Joseph Garruba
28 Winchester Dr.
Hollis, NH 03049
2/7/2020

To: Members of the Hollis Planning Board

Issues With the Proposed Development of Tax Map 41 Lots 25, 28 and 44 Including Review of Developer's **FOURTH** Alternate Roadway-2 Layout Submitted on 1-28-2021

Figure 15. Combined Profile From Developers Conceptual Site Plan Received 7/27/2020

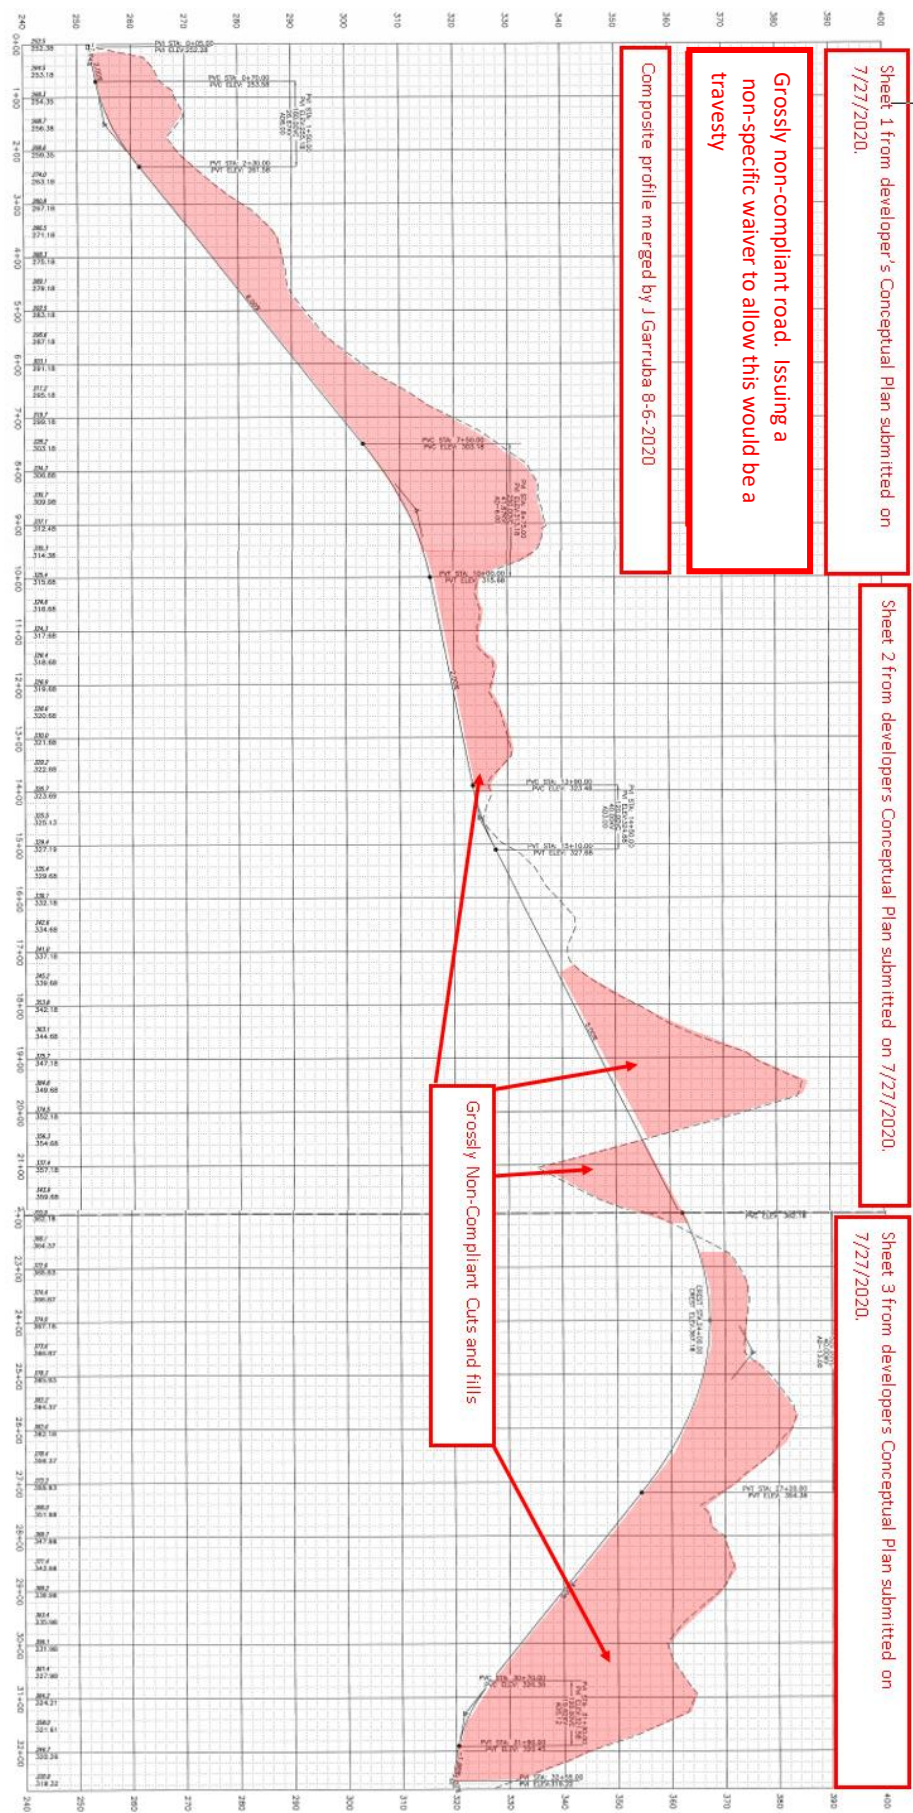
Review of the developer's **preferred** road profile shows many egregious non-compliances. On the following page is a composite image of the developer's preferred road profile, as provided on 7/27/2020. Sheets 2, 3, and 4 have been combined to provide the reader with a continuous view. One can see that there are four areas where cut or fill is proposed at 4-foot depths for more than 150 feet. This is the road design the developer intends to build if the Planning Board grants a waiver for the entire proposed length of the road.

The amount of material removal in the developer's preferred layout is astounding. This same developer is presently having difficulty completing a project of much smaller scale in the Keyes Hill development. What could justify granting a waiver of this magnitude? How many cubic yards of earth are proposed to be removed? The amount of noise and truck traffic from an operation of this scale will be overwhelming. Will the developer even be able to complete this project? They have been repeatedly delayed by "unusually hard" rock at the Keys Hill project. Why would we as a town put the abutters of another project through the ordeal that the Keys Hill abutters have been subjected to? I am requesting that the Planning Board withhold a waiver of the road requirements of our subdivision regulations for these reasons. The developer should be required to minimize cuts and fills and to build a compliant project that does not require waivers.
